## PLANNING & ZONING COMMISSION

- 4. Deliberation and take any appropriate action on the Legacy Park Addition Preliminary Plat.
- 5. Deliberation and take any appropriate action on the Multi-Family Dwellings portion of the City Ordinance to prepare for future consideration.

RE: Legacy Park Addition – Preliminary Plat HEI Job Number 385001-86.32

LEGACY PARK ADDITION 57.174 ACRES OF LAND 73 RESIDENTIAL LOTS

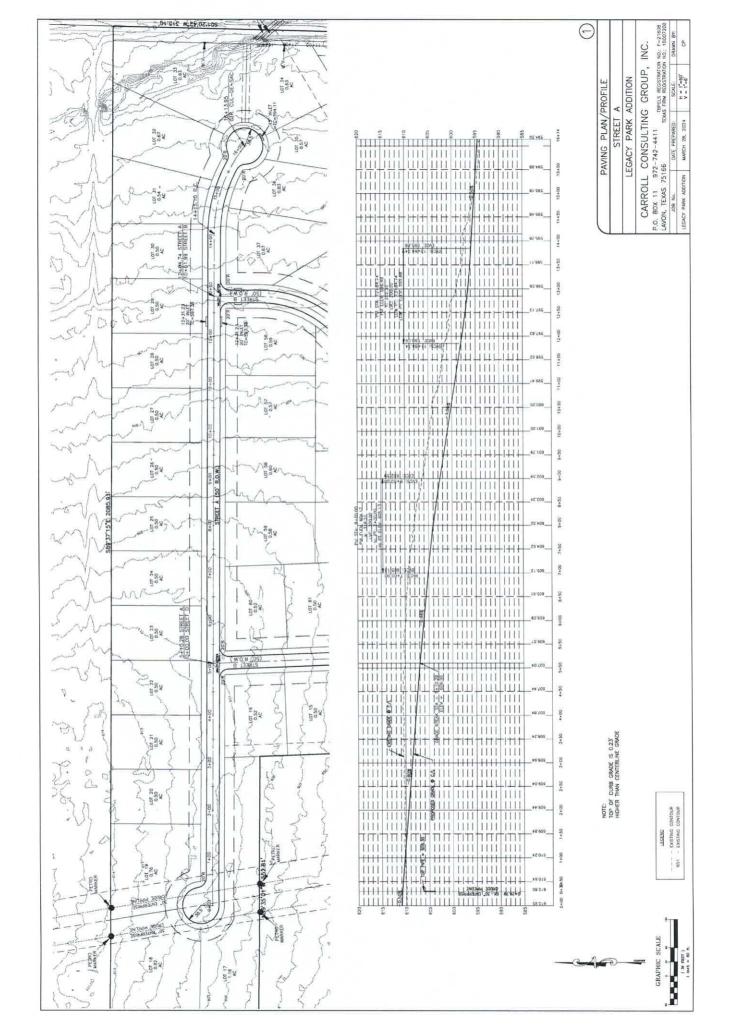
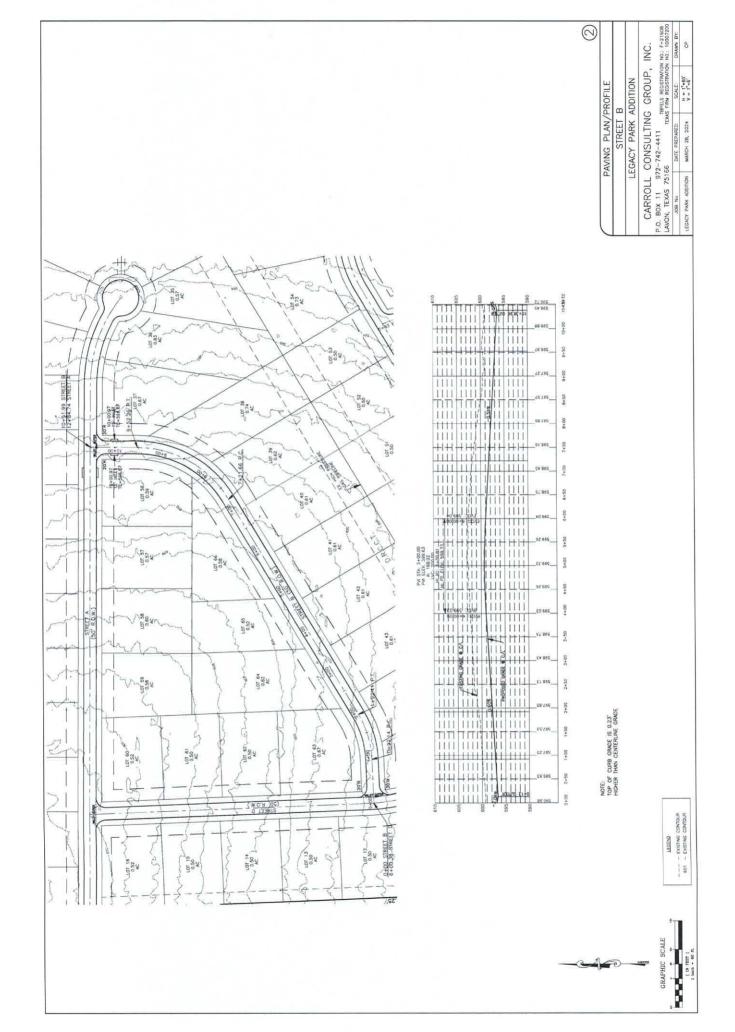
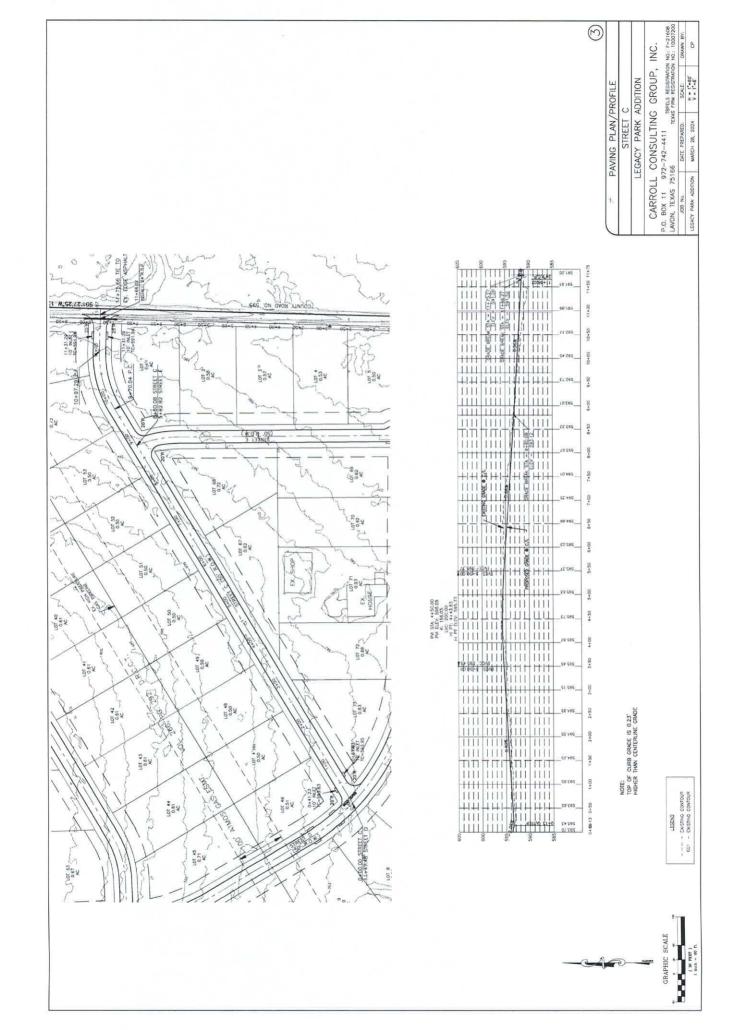
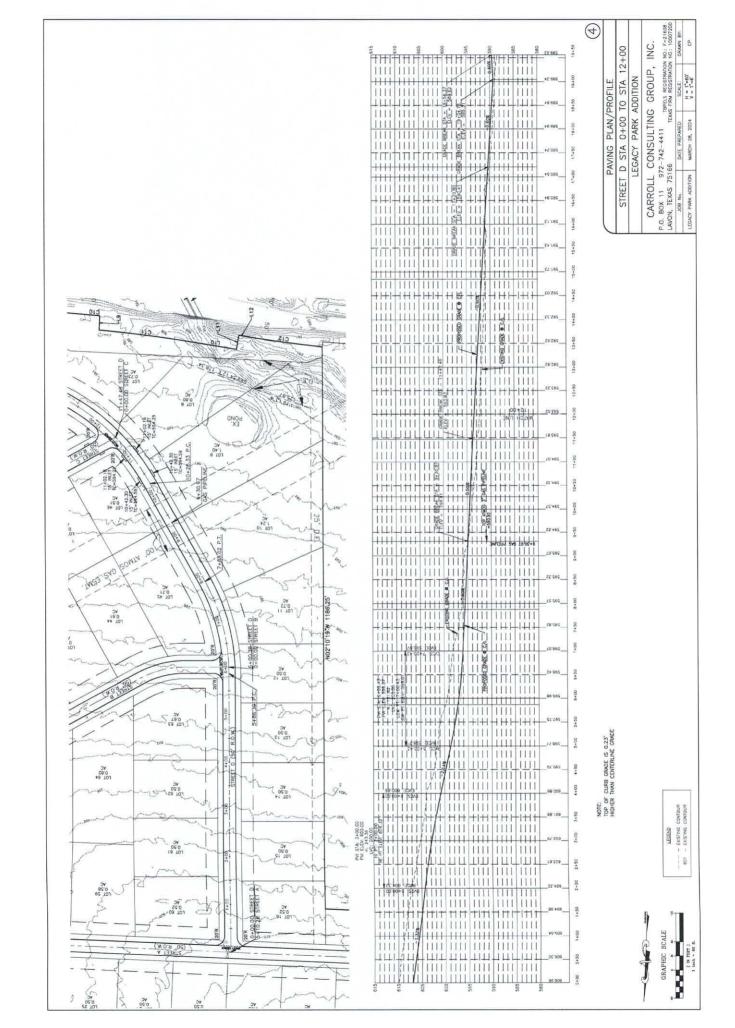
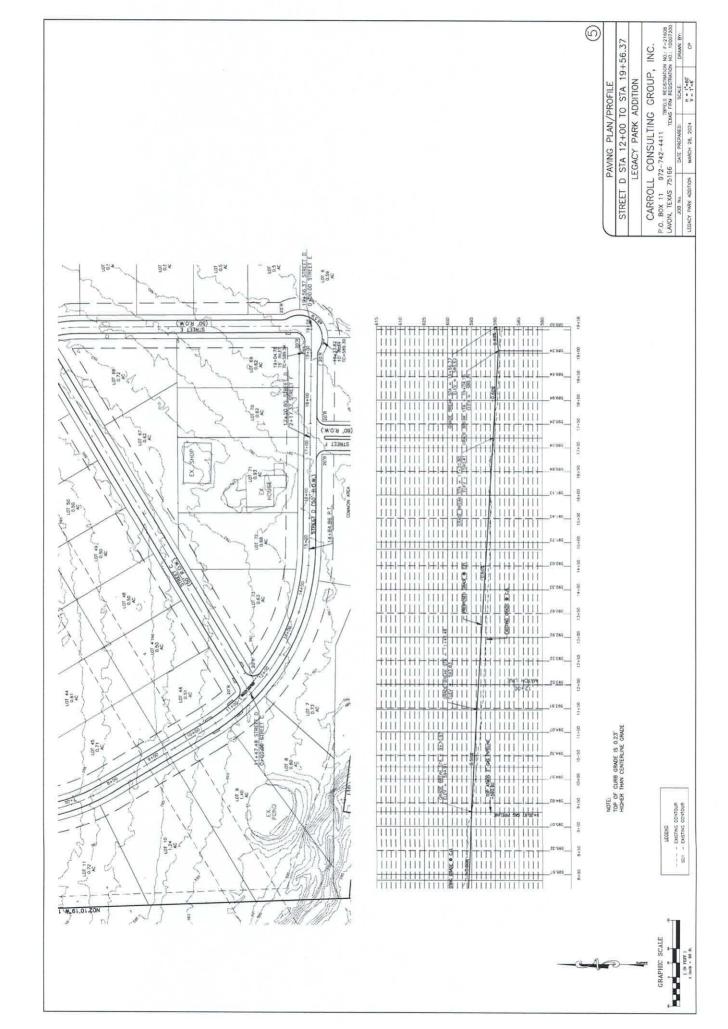
- 1. A closure report shall be submitted (Ordinance No. 17-14, Article IV, Sec. 17).
- 2. Ensure labels do not cover up/overlap other labels (Ordinance No. 17-14, Article IV, Sec. 17).

- 3. Called boundary line bearings do not match bearings noted in the metes and bounds description on page two (Ordinance No. 17-14, Article IV, Sec. 17 (1) a).

- 4. The ½ inch iron pin found, at the point of beginning, called for in the metes and bounds description is not shown on page one of the plat (Ordinance No. 17-14, Article IV, Sec. 17 (1) a).

- 5. Denote the existing roadway width of CR 595 and FM 6 (Ordinance No. 17-14, Article IV, Sec. 17 (1) b).
- 6. Show existing features such as existing driveways, buildings, pools, and other structures (Ordinance No. 17-14, Article IV, Sec. 17 (1) b).

- 7. Show the existing city limit boundary on the plat (Ordinance No. 17-14, Article IV, Sec. 17 (1) b).
- 8. There is an existing 100-foot-wide Atmos gas easement running northeast through the subject property. The plat should list any restrictions (e.g. fencing, structures, OSSF) within this easement (Ordinance No. 17-14, Article IV, Sec. 17 (1) b).

- a. Typically, Atmos allows very little within their easement. Assuming that is the case, Lots 46 through 53 are for all intents and purposes only approximately 0.35-acres.

- b. If Atmos does not allow portions of a lot's OSSF within their easement, this could further reduce the buildable area of these lots.

- 9. There is an existing 110-foot-wide Seaway crude pipeline easement cutting across the northwest corner of the subject property. The plat should list any restrictions (e.g. fencing, structures, OSSF) within this easement (Ordinance No. 17-14, Article IV, Sec. 17 (1) b).

- a. Provide confirmation that the Seaway easement does not cross any other portions of the subject property as it extends southeast toward FM 6.
- 10. Confirm there is no TxDOT drainage easement along the channel that crosses under FM 6 near the southwest corner of the subject property (Ordinance No. 17-14, Article IV, Sec. 17 (1) b).

- 11. Provide confirmation from both Atmos and Seaway that they have reviewed the proposed development and have no issues with the roads, utilities, and lots that are within their easements.

- 12. Show and label existing utilities including water lines, valves, hydrants, franchise utilities (e.g. fiber, electric, gas, cable), driveway and roadway culverts (Ordinance No. 17-14, Article IV, Sec. 17 (1) c).

- 13. The metes and bounds description call out three tracts (3.00-, 15.04-, 39.13-acre) within the platted area. These tracts should be identified with a unique line type and labeled (Ordinance No. 17-14, Article IV, Sec. 17 (1) e).

- 14. It is unclear who will own and maintain Common Areas A and B (Ordinance No. 17-14, Article IV, Sec. 17 (2) e).
- 15. There is an existing creek that runs through Lots 32, 33, and 34. The existing creek should be placed in a drainage easement (Ordinance No. 17-14, Article IV, Sec. 17 (2) f).

- 16. For all intents and purposes, Lot 9 is only 80-feet wide. Depending on the Atmos easement restrictions and orientation and square footage of the future house, access to the backyard could be severely limited (Ordinance No. 17-14, Article IV, Sec. 17 (2) g).

- 17. The development of Lot 33 will be impacted by the existing channel and associated flood boundary. Based on the results of Base Flood Elevation (BFE) determination (see comments below), care should be taken to ensure this lot is truly developable. It is possible that this lot will need to be combined with an adjacent lot to provide sufficient space for future development (Ordinance No. 17-14, Article IV, Sec. 17 (2) g).

- 18. As mentioned above, Lots 46 through 53 could be severely impacted by the Atmos gas easement. It is possible that these lots will need to be modified to accommodate the easement and provide sufficient space for future development (Ordinance No. 17-14, Article IV, Sec. 17 (2) g).

- 19. There are two creeks that cut through the subject property, one near the northeast corner (Lots 32, 33, and 34) and another near the southwest corner (Lots 7, 8, and 9). While neither channel is within a FEMA designated Special Flood Hazard Area (SFHA), that does not mean that both channels do not have an associated floodplain. Base Flood Elevations (BFE) should be determined and mapped for both channels (pre- and post-project conditions) to determine potential impacts both channels and the associated roadway crossings will have on lots within the subject tract as well as adjacent properties to the subject tract. Doing this will aid in setting finished floor elevations and determining where structures should and should not be located on impacted lots. Furthermore, any proposed fill being placed within the determined flood limits should be accounted for too. Ultimately, there can be no adverse impacts to adjacent property owners. (Ordinance No. 17-14, Article IV, Sec. 17 (2) i).

- 20. Based on the submitted plat, there appears to be no proposed detention pond(s) to ensure post-development flows do not exceed pre-development flows. Please provide an explanation as to why a detention pond(s) is not required. Alternatively, a downstream assessment showing the

- existing downstream facilities can handle post-development flows would be an acceptable alternative (Ordinance No. 17-14, Article IV, Sec. 17 (3)).
- 21. Please provide evidence that the existing CR 595 culverts and FM 6 culverts are sized to handle the post-development runoff. If they are not, then the culverts will need to be upsized accordingly. Regardless of the outcome, BFEs should be determined and mapped to show the culverts' impacts on the proposed development (Ordinance No. 17-14, Article IV, Sec. 17 (3)).
- 22. A typical cross section of the proposed roadways should be included on the plat (Ordinance No. 17-14, Article IV, Sec. 17 (5)).
- 23. The preliminary plat approval block should be updated to match the wording found in the City's Subdivision Ordinance (Ordinance No. 17-14, Article IV, Sec. 17 (6)).
